PN 21-130787
V07 House – 2nd Floor Renovation
Type of Original Notice: Documented Quote
Notice Number: 21-130787

ADDENDUM 1

V07 HOUSE 2ND FLOOR RENOVATION

A01.02.2

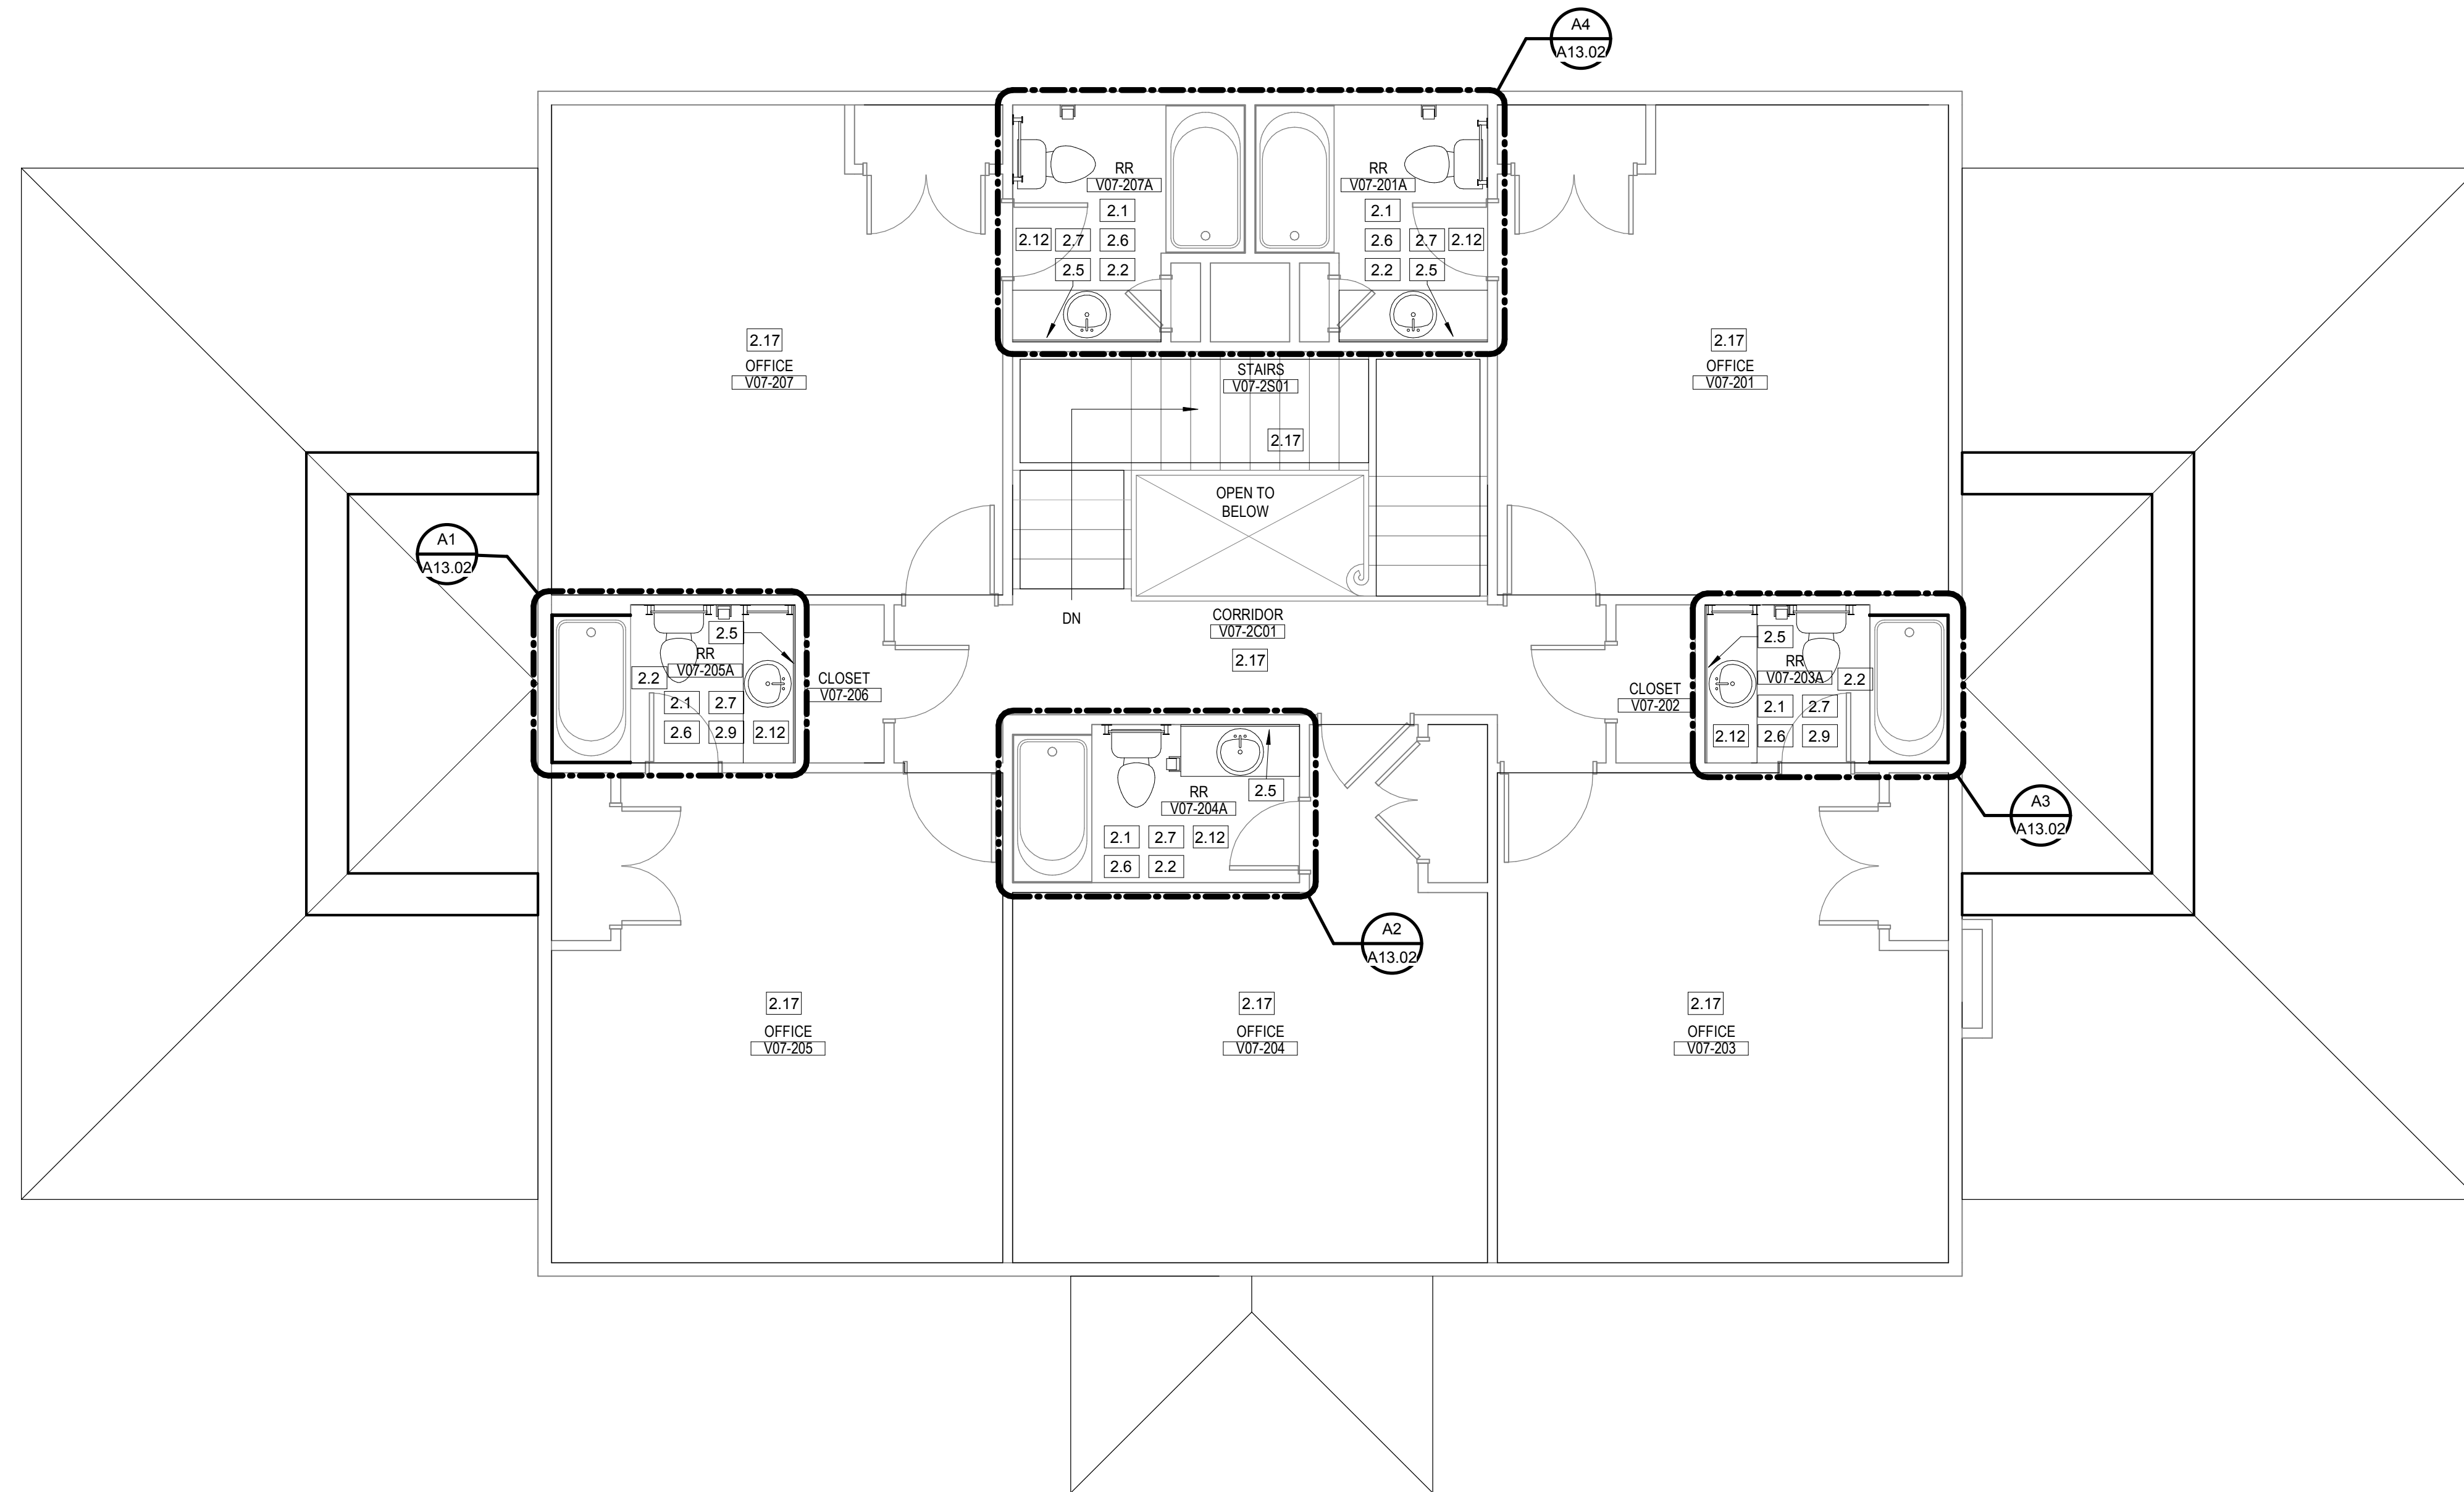
8. Is professional Liability required since we did not do the drawings? *Response: No*
9. The restrooms, 201A, 204A, 207A that the wall tile in the tubs stays. Sheet A01.02.2 calls for the tub and shower trims to be changed out. Is there existing replacement wall tile so these valve assemblies can be change out and the walls repaired with? If not what do we do to gain access to these valves? *Response: There is no attic stock of tile. If it is possible to replace the valve without damaging the existing wall tile, that is preferred. Price the project scope as written. If it is determined that the valve cannot be replaced without damage to the wall tile, the OAC group will deal with that issue during construction.*

10. There are nice restroom towel racks are these being replaced with new? *Response: Yes, they are being replaced with commercial-grade fixtures.*
11. Can we get a model number for the wall sconces going into the restroom? *Response: Please see attached sheet A01.02.2 with Lighting Fixture noted.*

A12.02.2

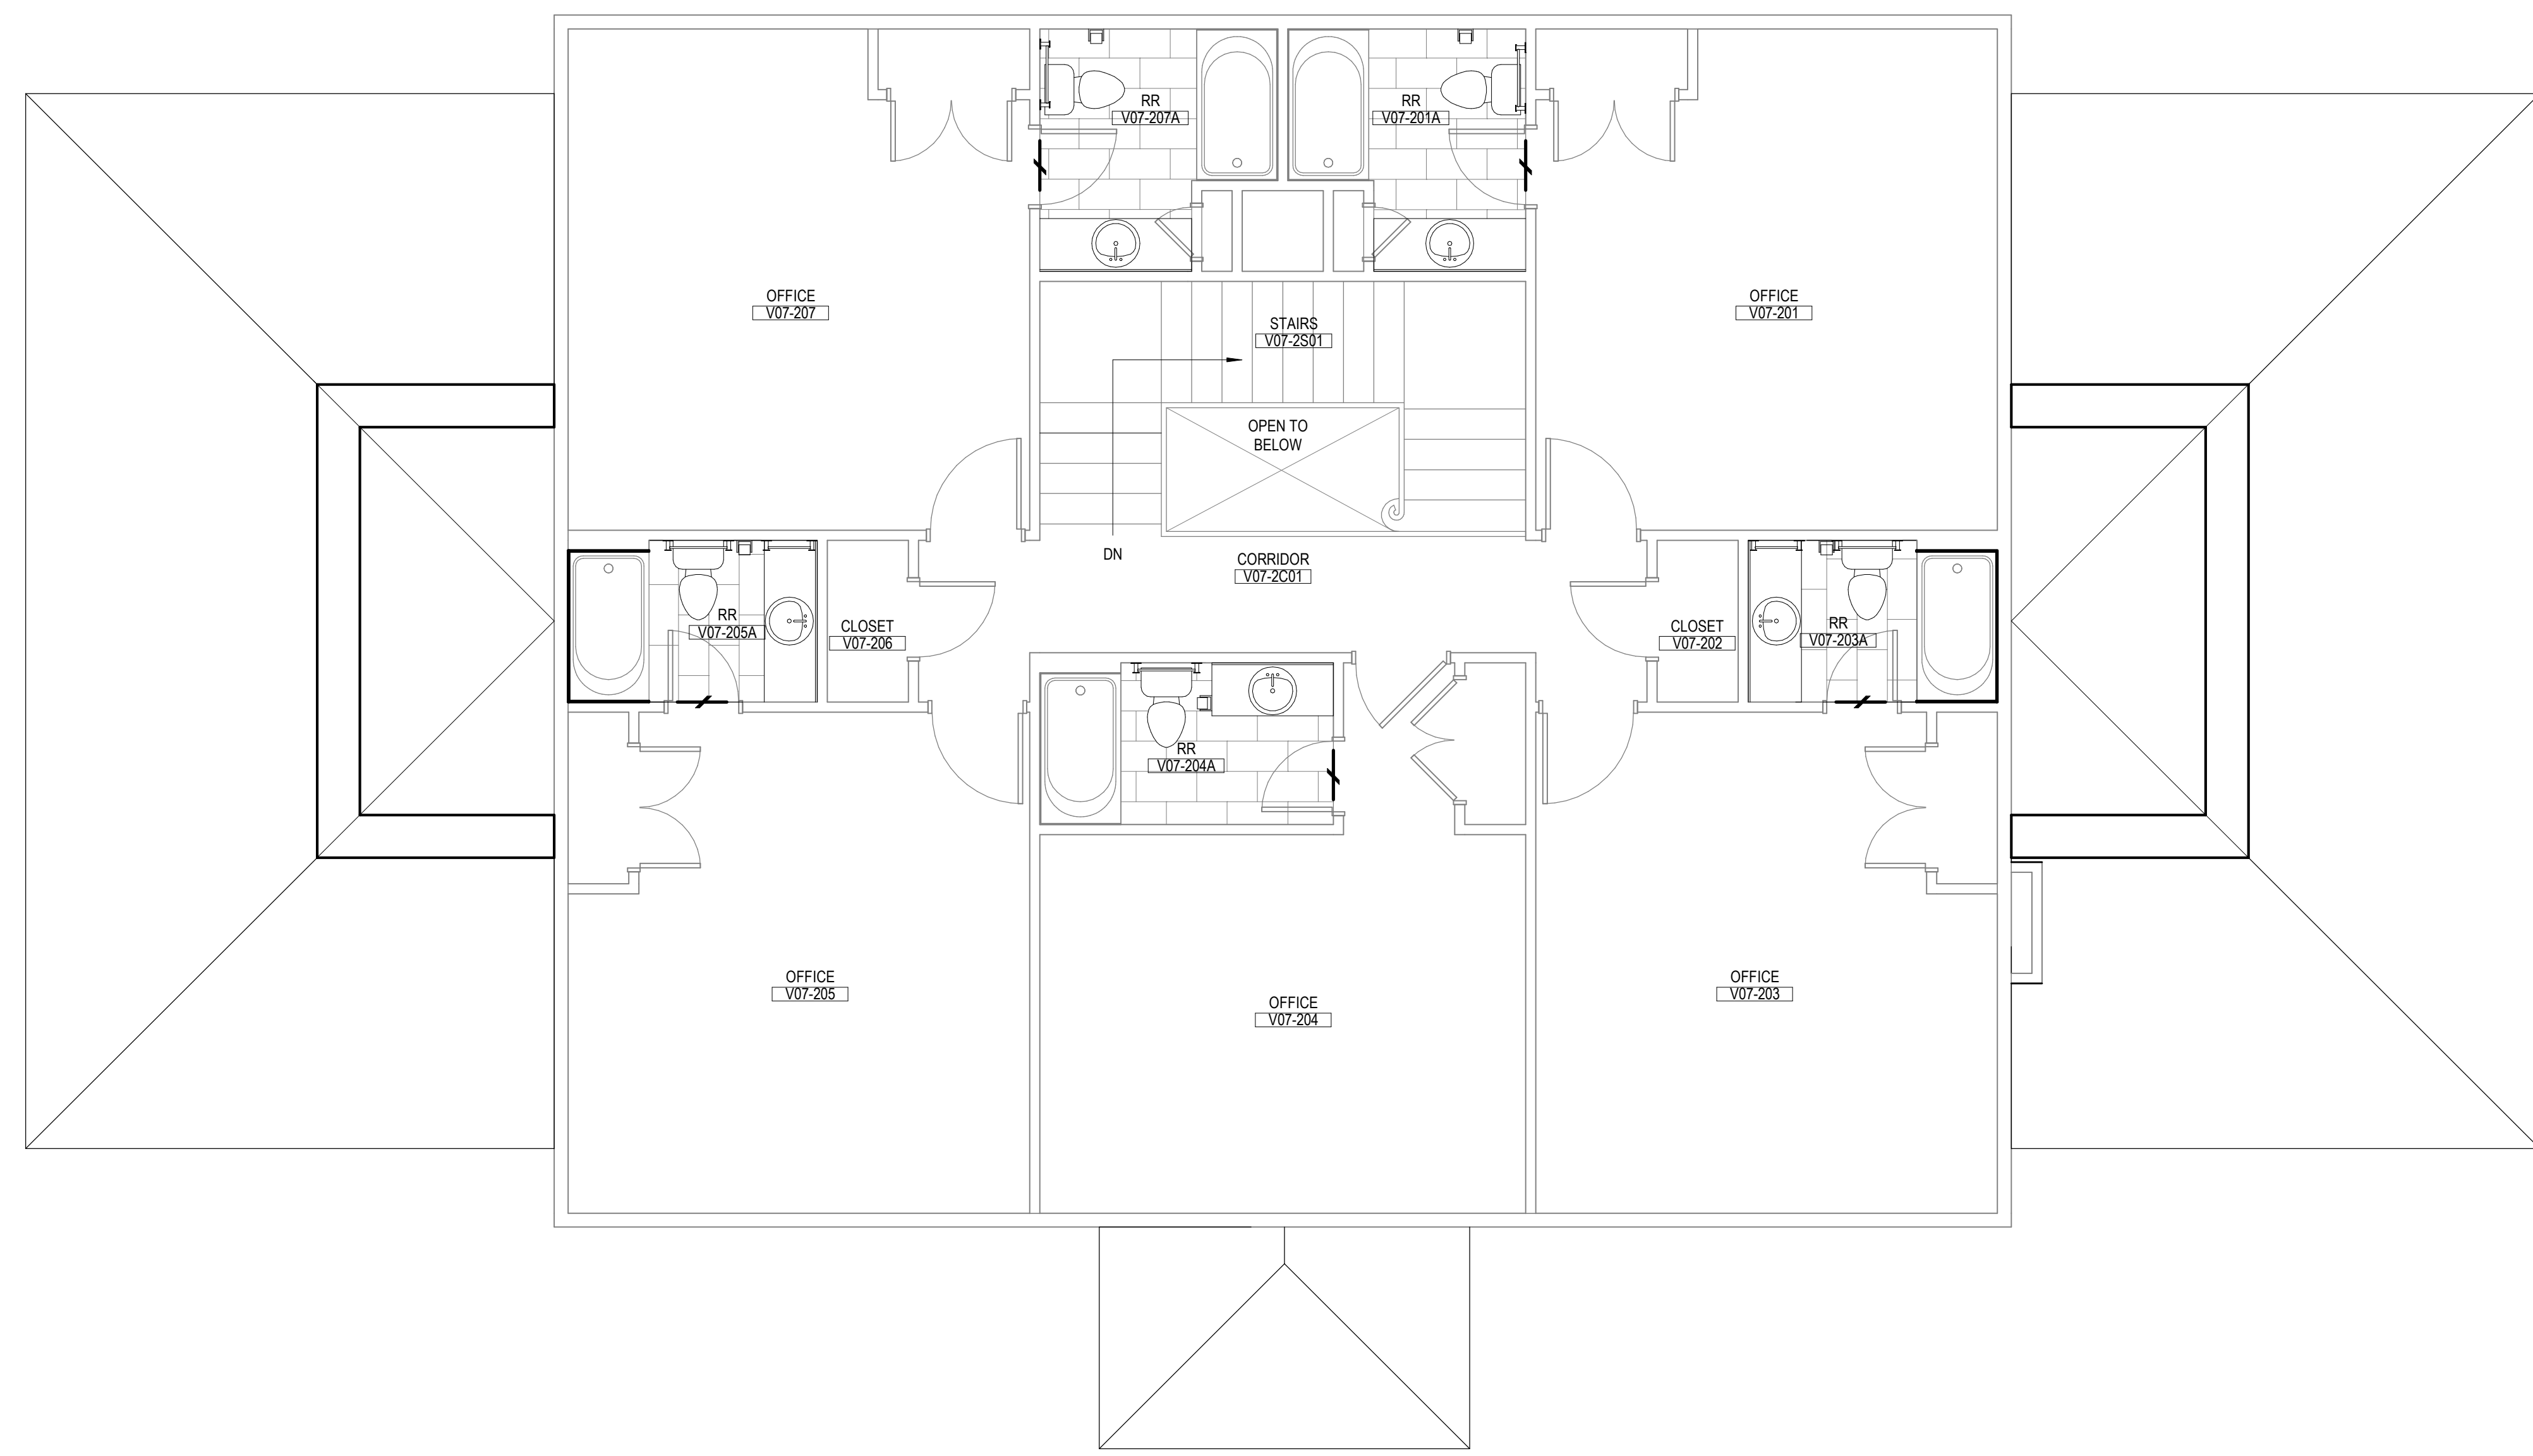
3. Spec 123661.19-2, The Quartz Agglomerate Solid sheet is made by Silestone. Is there a color or group to match for pricing? Product not shown on drawings in finish schedule. *Response: Please see attached revised Material Legend on sheet A12.02.2*

16. Please advise where T2 is utilized, I don't see it on the elevations. *Response: Tile T2 was not used for this scope. Please see attached revised Material Legend on sheet A12.02.2*
